Request IR-1:

Response IR-1:

Laframboise General Complaint (NSEB M12536)
NSPI Responses to NSEB Information Requests

NSPI & BELL CANADA JOINT-USE DISTRIBUTION STANDARDS**JOINT-USE CLEARANCES SERVICE ATTACHMENTS FOR SINGLE FAMILY DWELLINGS**

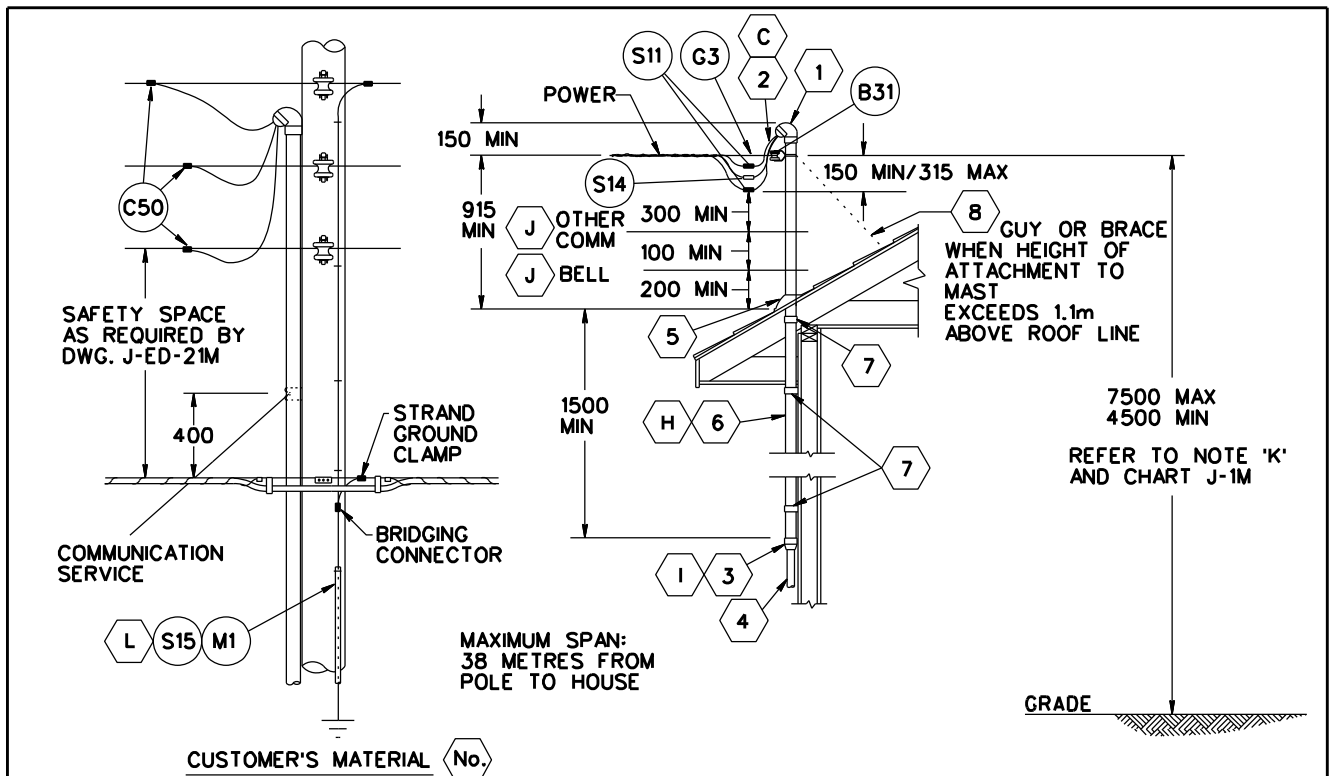
During the review, the customer’s residence was evaluated using a Google Maps image to determine whether an overhead service mast installation could meet the clearance and termination requirements under the CE Code and Utility Service Requirements. Due to the proximity of the structure to adjacent homes and the height and location of nearby window openings, a compliant overhead service installation is not feasible.

NS Power assessed the required mast height, routing of the consumer’s service conductors, and the clearance requirements relative to neighbouring windows. In accordance with CE Code Rule 6-112(4), both utility and consumer service conductors must maintain a minimum horizontal clearance of 1 metre from any window. Given the building’s design and dormer windows, any feasible mast placement would result in the conductors passing too close to adjacent windows. To achieve the 1-metre horizontal window clearance, the service raceway would need to be installed either: below 4.5 metres, or above 7.5 metres, neither of which complies with the Utility Service

1 Requirements Drawing J-ED-23M (attached as IR-4 Attachment 1), as these configurations would
2 result in a non-compliant termination height and service attachment point.

7
8 The only hypothetical configuration that might achieve the necessary clearances would involve
9 attaching the mast to a neighbouring structure. This is not permitted under CE Code Rule 6-102,
10 which prohibits installing utility supply conductors on a structure unless it is the single, completely
11 self-contained structure being served.
